8500 BELL CREEK ROAD MECHANICSVILLE, VA 23116 (804) 569-7060 FAX: (804) 569-7061 \Box C**5** 0 nsulting gineers REVISED TREE
PRESERVATION PLAN
SINGLE FAMILY DETACHED RESIDENTIAL
HUGUENOT DISTRICT, CITY OF RICHMOND, VIRGINIA SCALE:
DATE:
REVISED:
SHEET N/A MAY 31, 2016

PROPOSED REVISION TO TREE SAVE PLAN

VILLAS AT ARCHER SPRINGS REVISED TREE PRESERVATION PLAN SINGLE FAMILY DETACHED RESIDENTIAL HUGUENOT DISTRICT, CITY OF RICHMOND, VIRGINIA

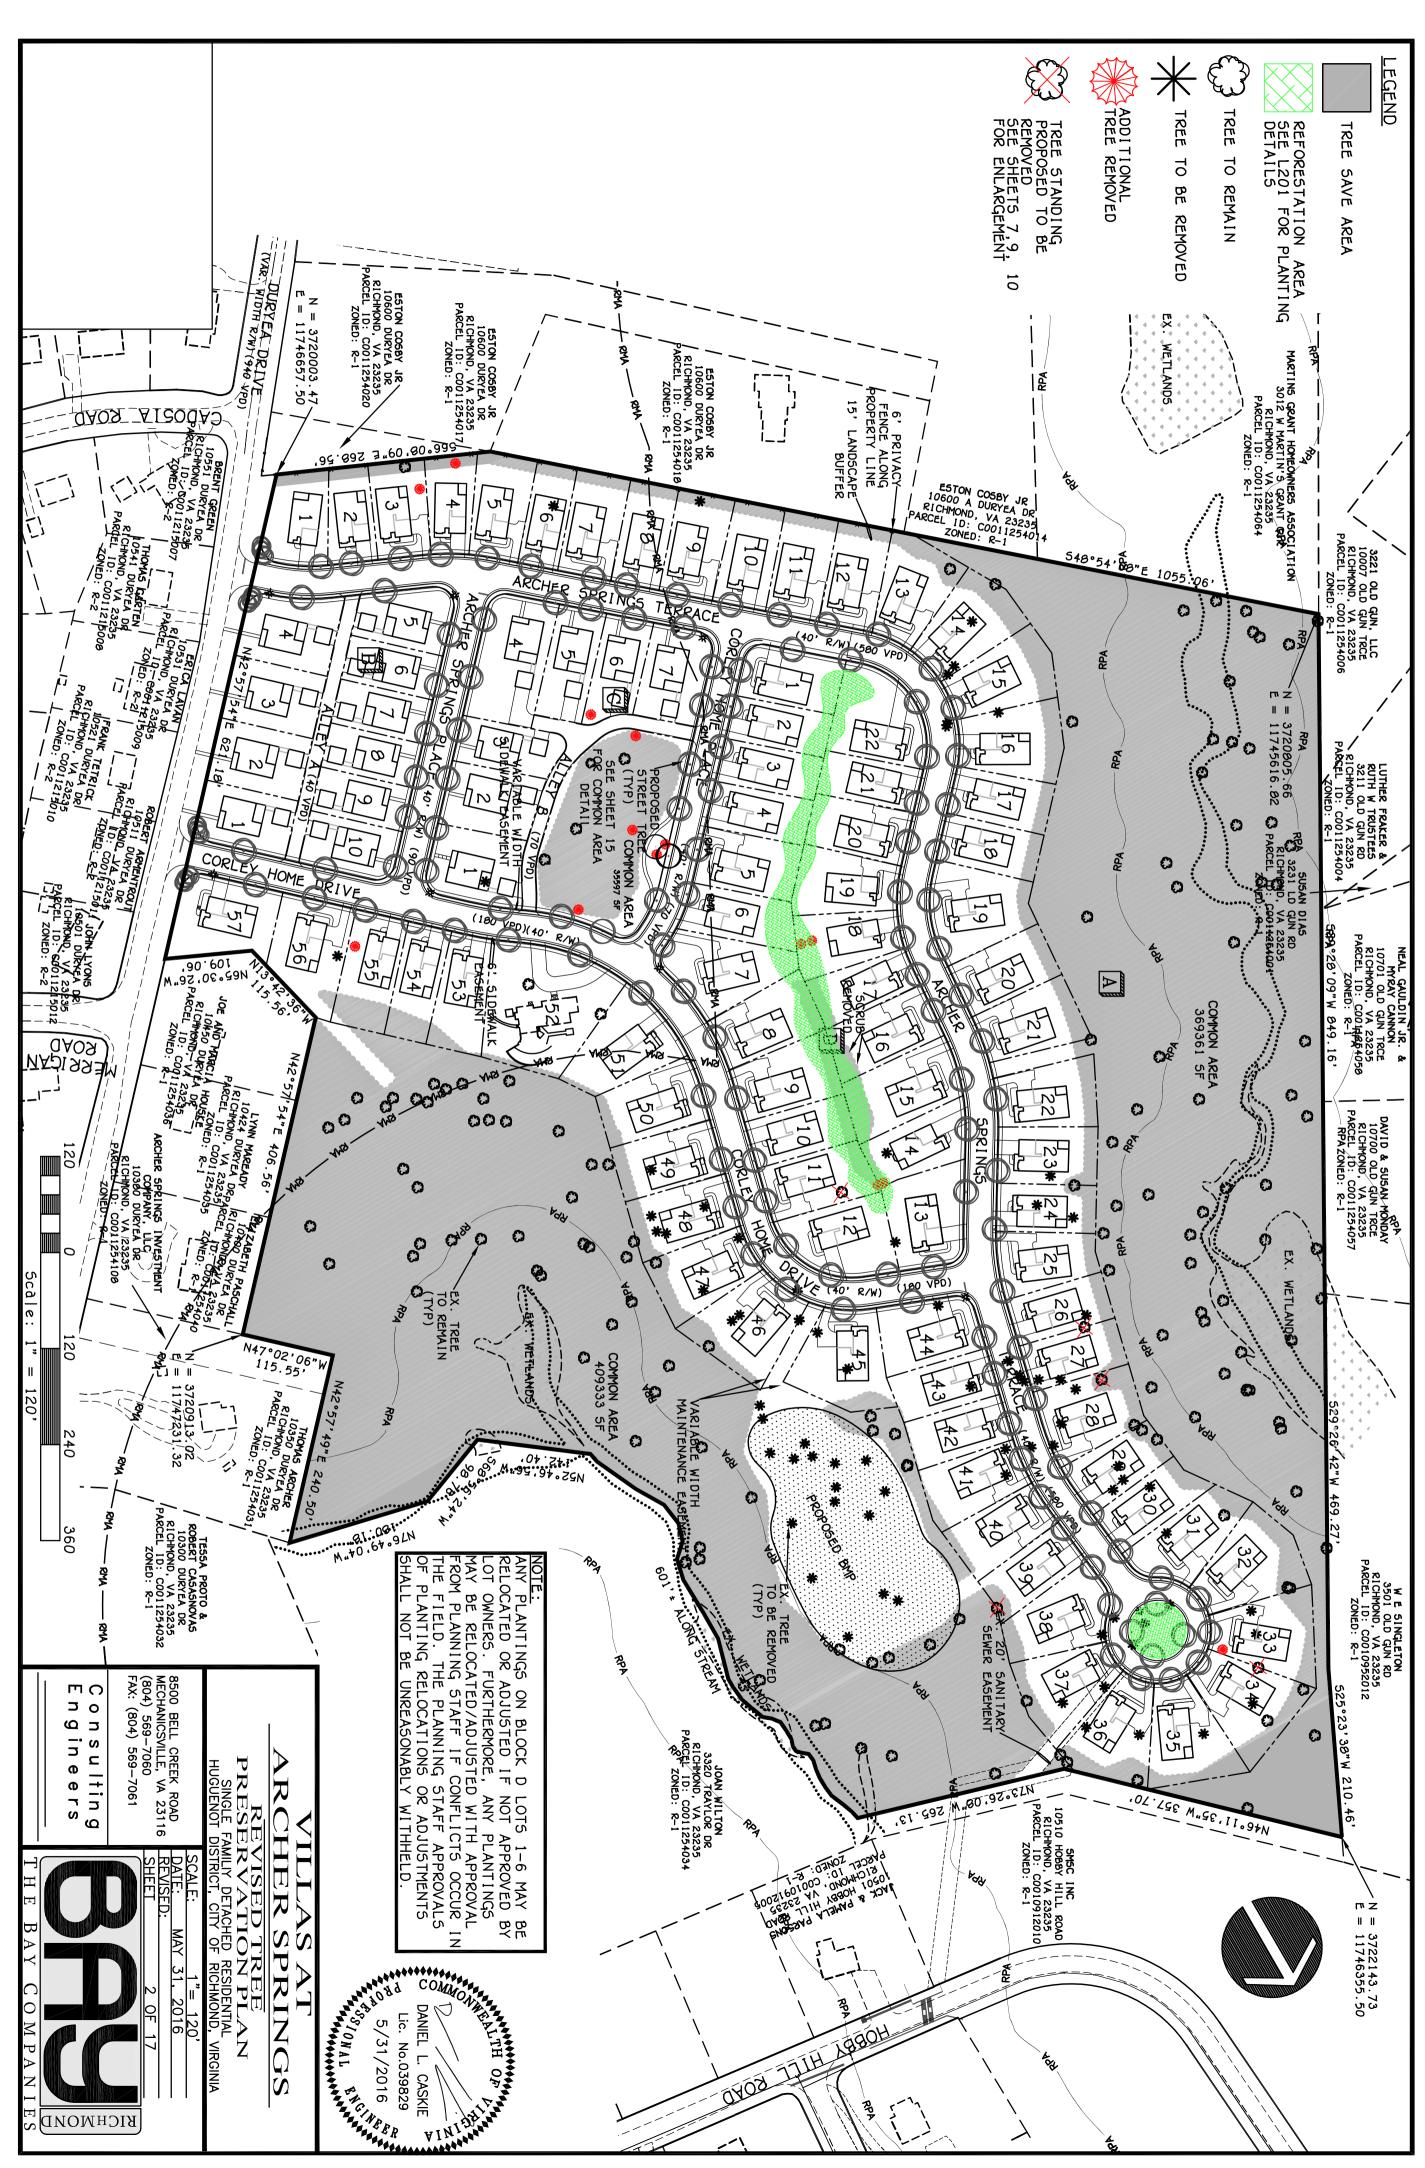
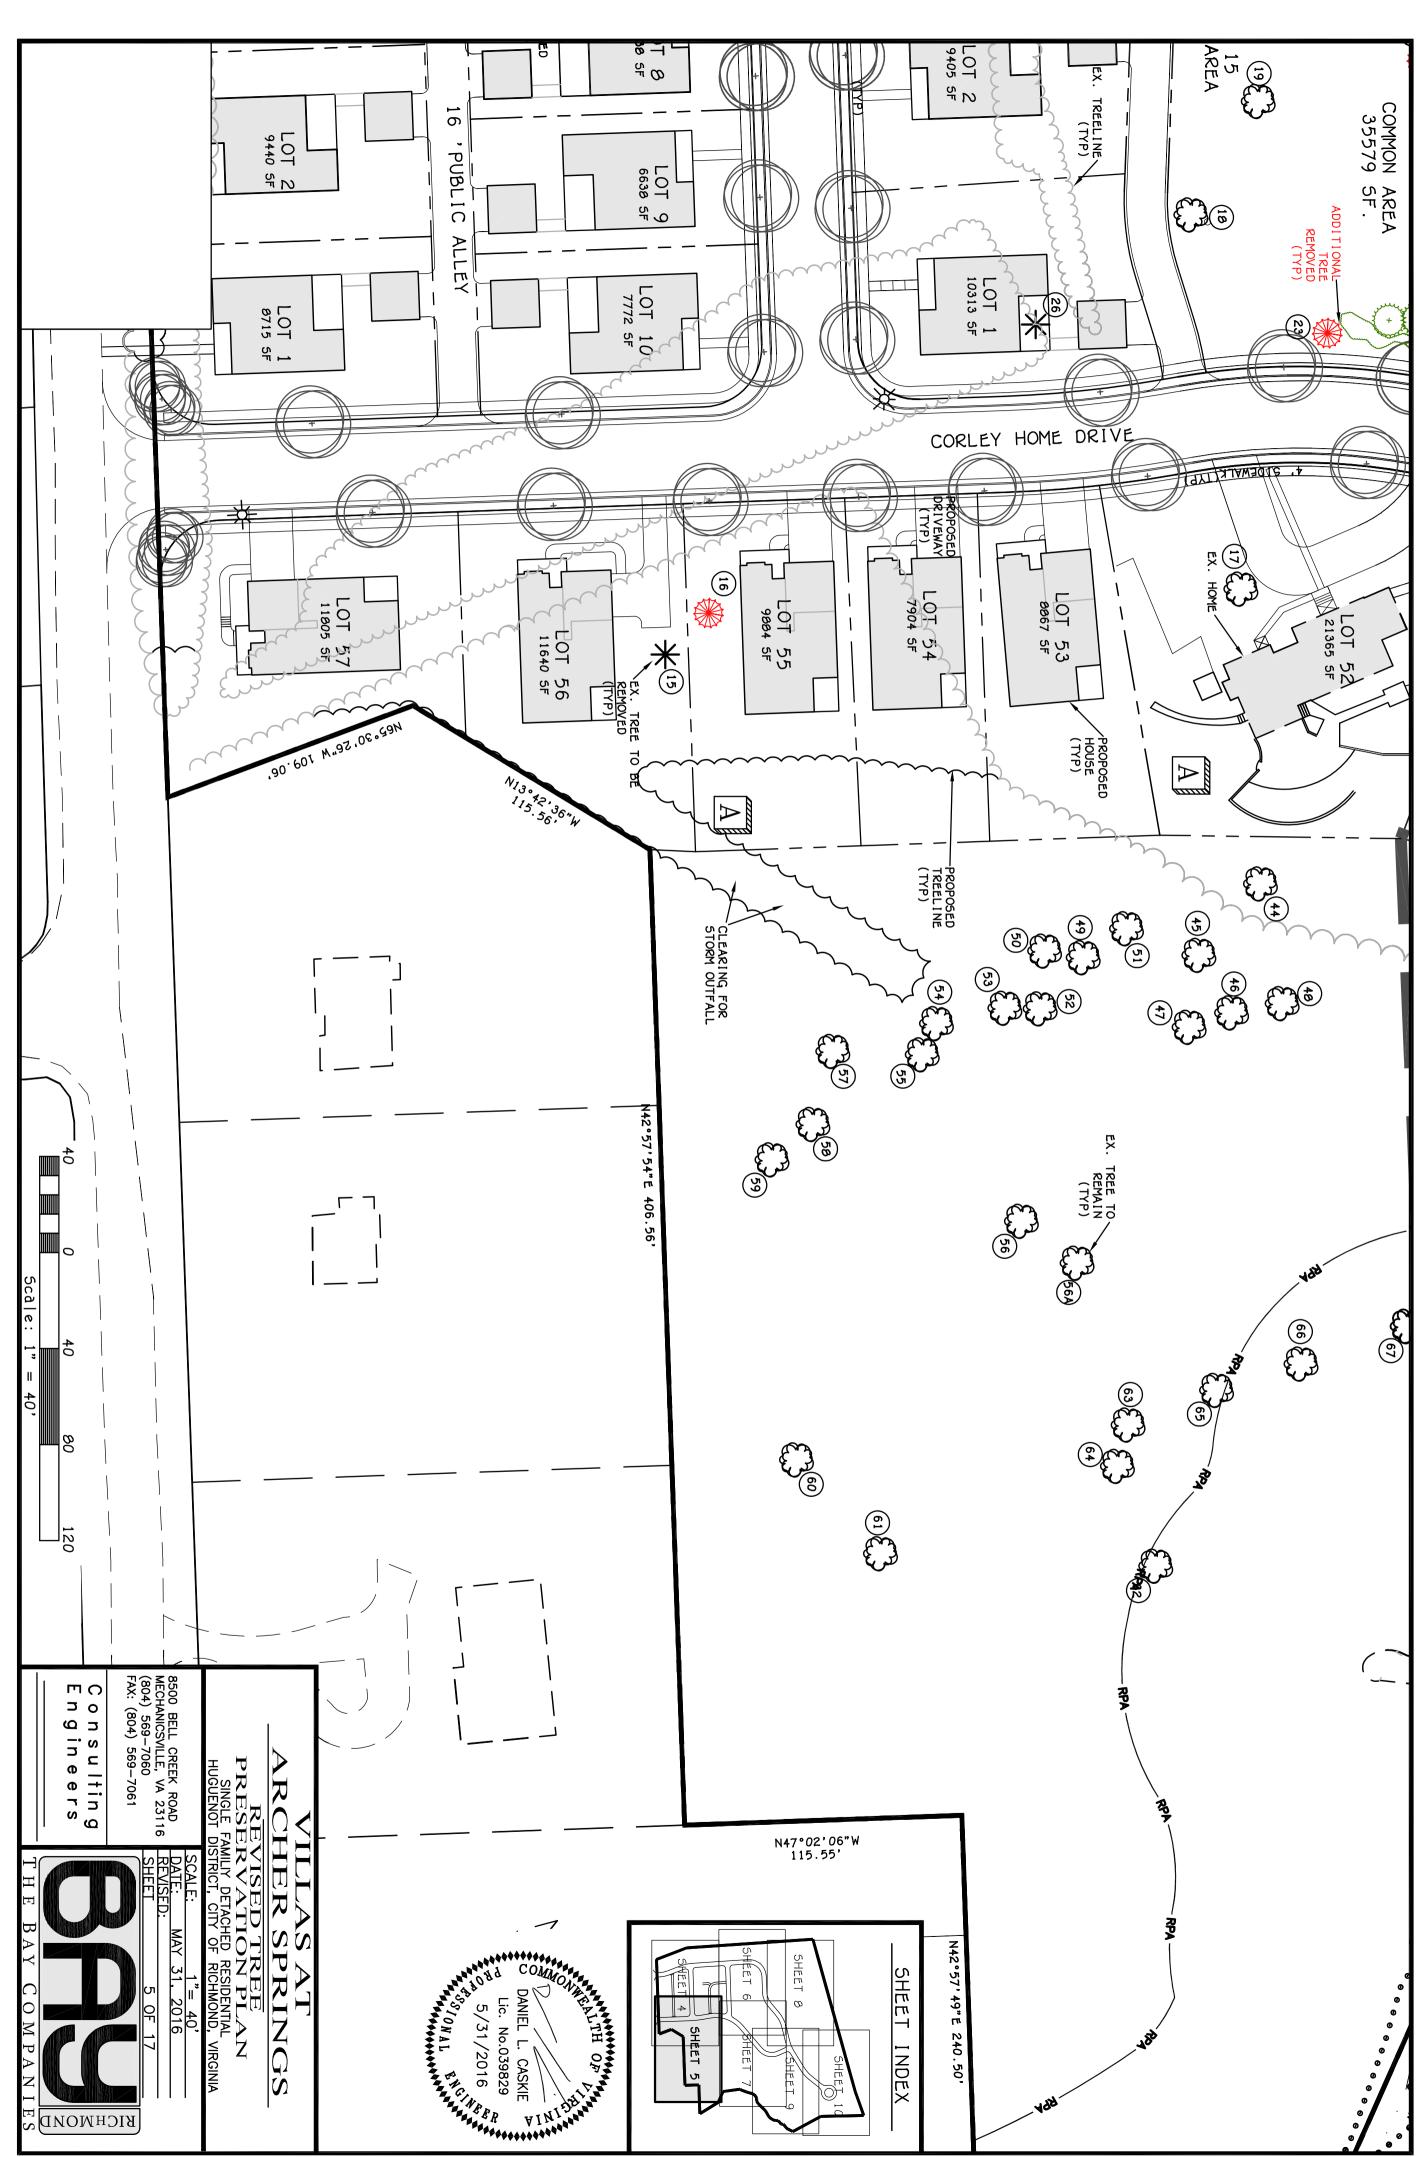
Tree Number Description		Status change explaination
24	38" Pecan	Orginally to be removed. Proposed to remain. Drive for Lot 51 relocated to accommate tree.
31	40" Oak	Orginally to be saved. Proposed removed. Tree has substantial death in crown & damaged trunk.
119	36" Maple	Orginally to be saved. Proposed removed. Crown of tree would conflict with roofline of homes.
135	36" Maple	Awaiting final approval from City after they review revised tree save plans.
193	38" Willow Oak	Orginally to be saved. Proposed removed. Crown of tree would conflict with roofline of homes.
234	38" Willow Oak	Orginally to be saved. Proposed removed. Crown of tree would conflict with roofline of homes.
